Re: NPDES Permit No. IN0000205
ArcelorMittal Indiana Harbor, LLC – Indiana Harbor West
East Chicago, Indiana
Lake County

A response to the comments received pertaining to the draft NPDES permit is contained in the Post Public Notice Addendum. The Post Public Notice Addendum is located at the end of the Fact Sheet.

INDEX
for
ArcelorMittal Indiana Harbor West NPDES Permit IN0000205

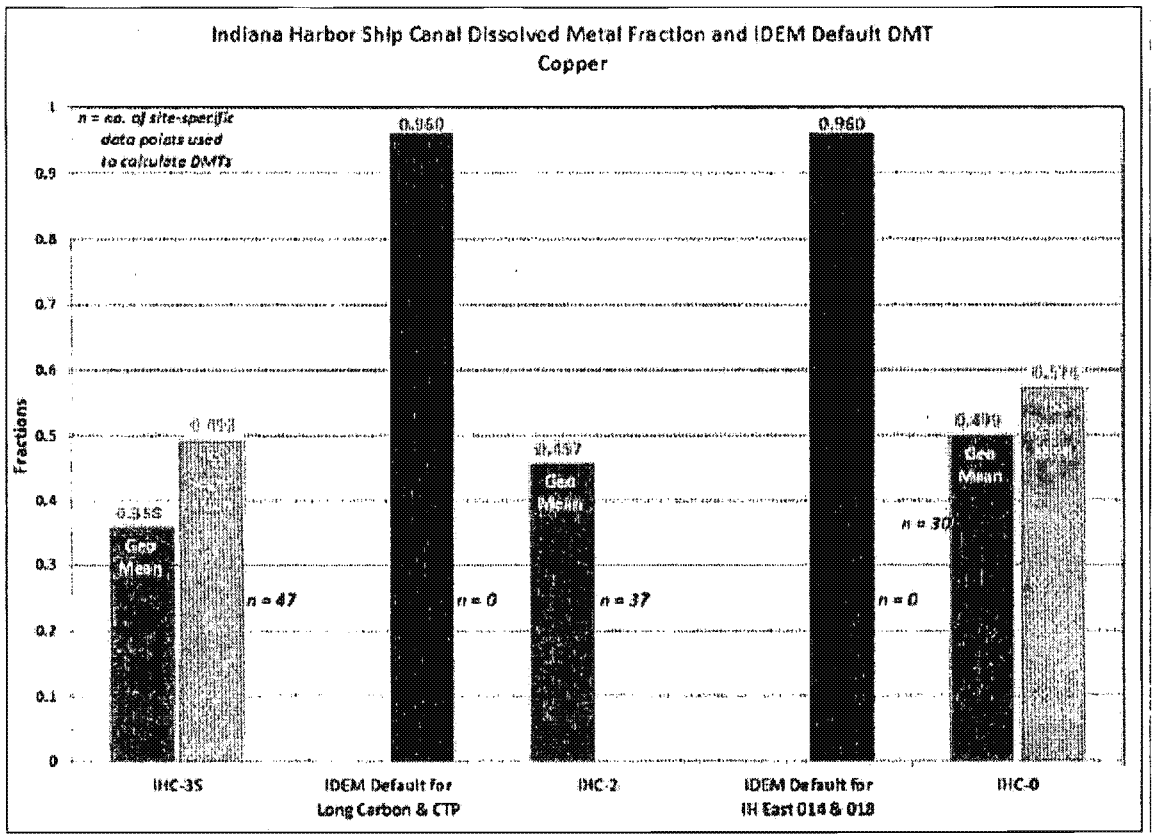
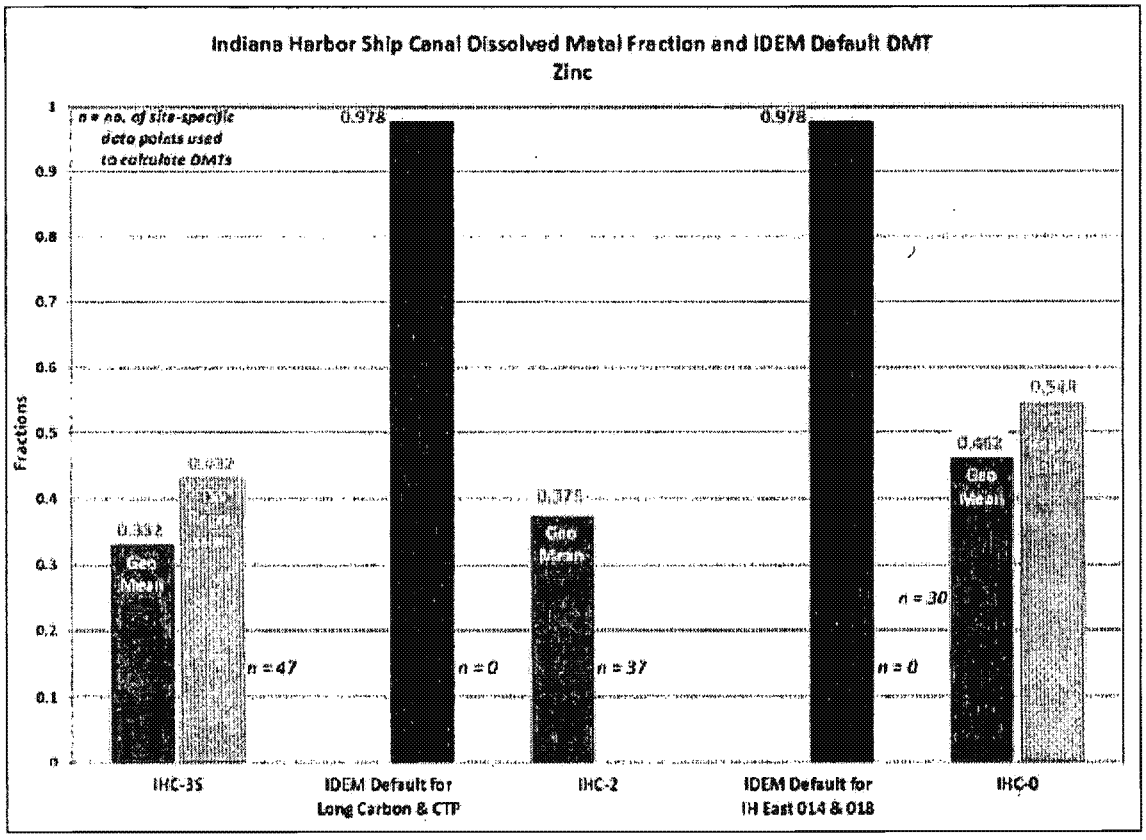
IDEM's default DMTs, which rely on no data specific to the IHSC, are clearly inaccurate for the ArcelorMittal permits and overestimate the dissolved copper, lead and zinc fractions in the IHSC by significant amounts. For example, the default translators are 2.1, 3.0 and 2.6 times greater than the calculated geometric mean of the dissolved fractions for copper, lead and zinc, respectively, at IHC-2. Even the 95th percentiles of the dissolved fractions for all metals at all locations are significantly below IDEM's default translators. As shown, the DMTs calculated at IHC-3S, IHC-2 and IHC-0 are considerably lower than IDEM's default DMTs used in the calculation of WQBELs. Graphs of the geometric mean dissolved fractions, TSS-regression developed DMTs, and IDEMs default DMTs are presented below.

Given the data presented in the table and graphs above, it is not reasonable to assume, as IDEM has done through use of the default DMTs, that the dissolved metal fraction in the water column somehow increases dramatically in between the fixed monitoring stations. ArcelorMittal's requested effluent limits, based upon site-specific DMTs derived from the IDEM fixed monitoring station data and other factors, are presented below.

ArcelorMittal Indiana Harbor West Intake No. 3 to the open waters of Lake Michigan:	~1,100 feet (~0.21 miles)
ArcelorMittal Indiana Harbor West Intake No. 2 to the open waters of Lake Michigan:	~5,300 feet (~1.0 miles)

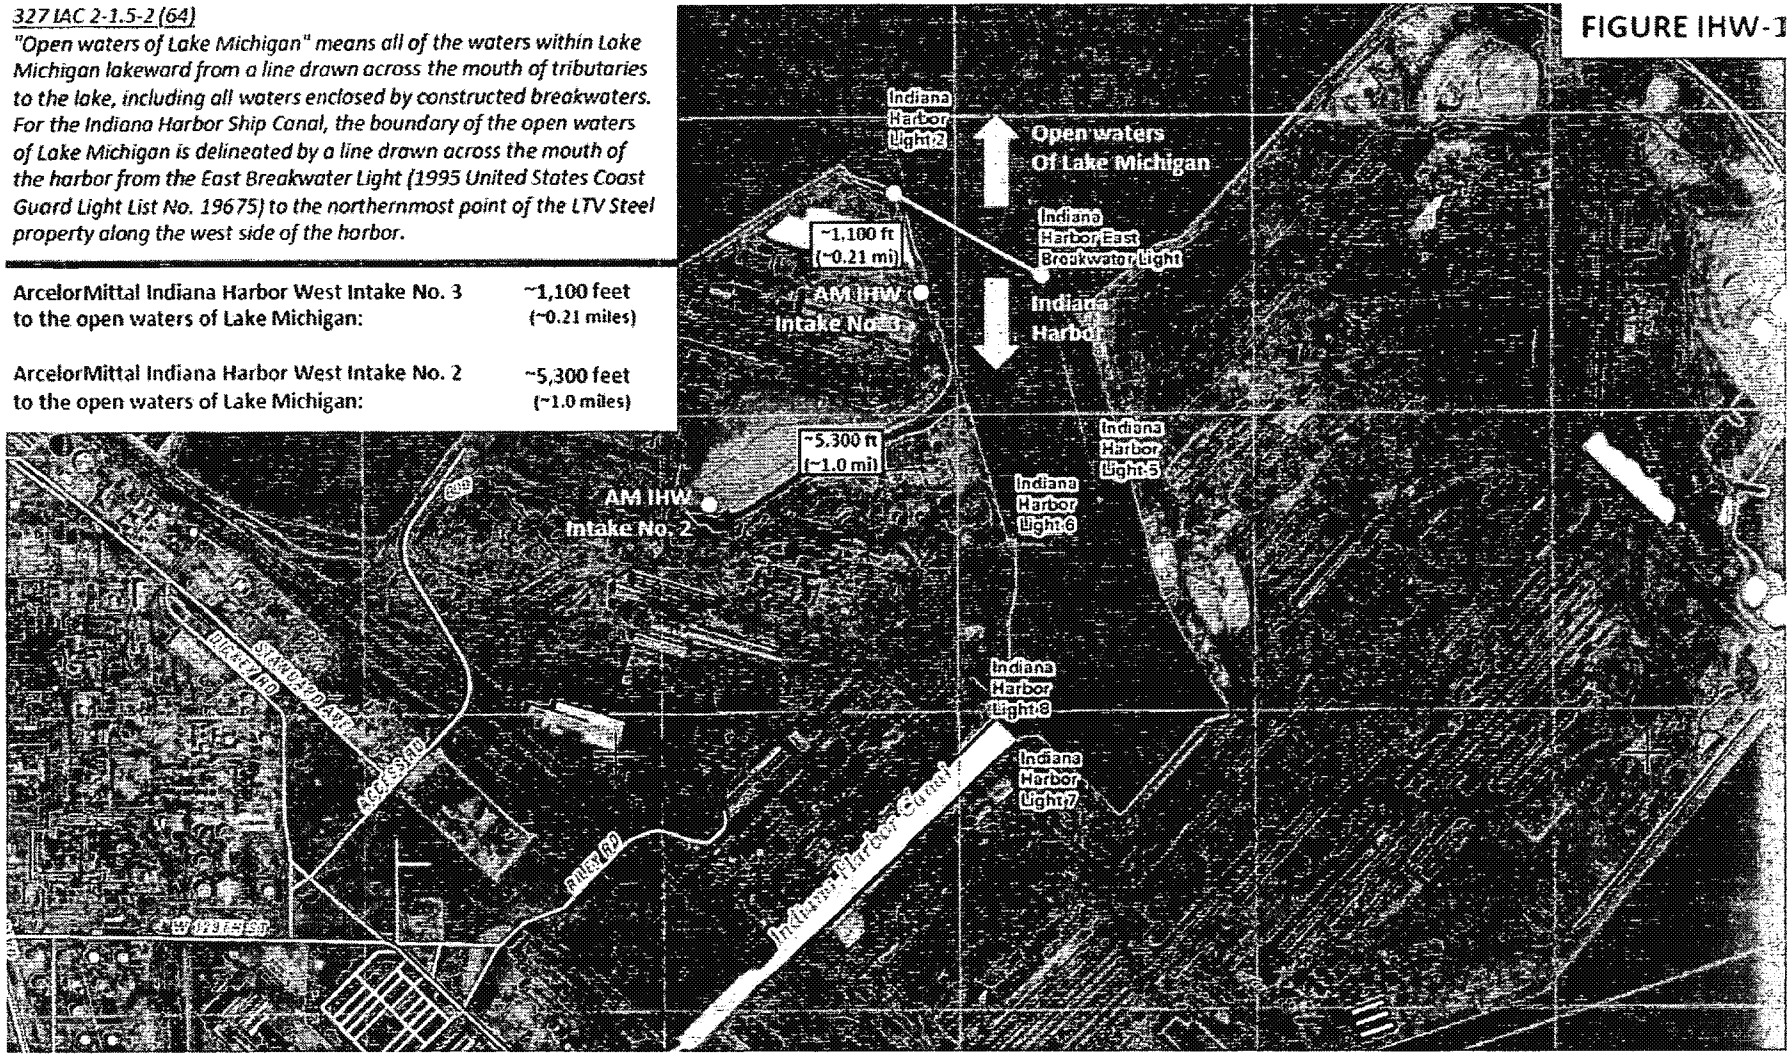
IDEM states in Attachment A of the Fact Sheet (p. 5), that Indiana Harbor West has two water intakes in Lake Michigan; and, that IDEM considers the intake channel for the Nos. 2 and 3 intakes as "open waters of Lake Michigan" (p. 12). Figure IHW-1 is an aerial photograph showing the Nos. 2 and 3 intakes, the intake channel and the northern section of the Indiana Harbor Ship canal that borders the open waters of Lake Michigan. A line depicting the boundary described in the above definition of "open waters of Lake Michigan" is shown on the aerial photograph. It is evident from a simple reading of the regulatory definition of "open waters of Lake Michigan" and review of the aerial photograph that the Indiana Harbor West intake channel and the Nos. 2 and 3 intakes are not within open waters of Lake Michigan. They are not lakeward of the line between the East Breakwater Light and the northernmost point of LTV Steel property (now ArcelorMittal Indiana Harbor LLC property). In fact, the No. 3 Intake is approximately 0.21 miles south of the northernmost point of ArcelorMittal property and the No. 2 intake is approximately 1.0 miles south and southwest of the northernmost point of ArcelorMittal property. Thus, IDEM's assertion that the intake channel for the Nos. 2 and 3 intakes are within the open waters of Lake Michigan is wrong, and any applications of Indiana water quality

"Open waters of Lake Michigan" means all of the waters within Lake Michigan lakeward from a line drawn across the mouth of tributaries to the lake, including all waters enclosed by constructed breakwaters. For the Indiana Harbor Ship Canal, the boundary of the open waters of Lake Michigan is delineated by a line drawn across the mouth of the harbor from the East Breakwater Light (1995 United States Coast Guard Light List No. 19675) to the northernmost point of the LTV Steel property along the west side of the harbor.
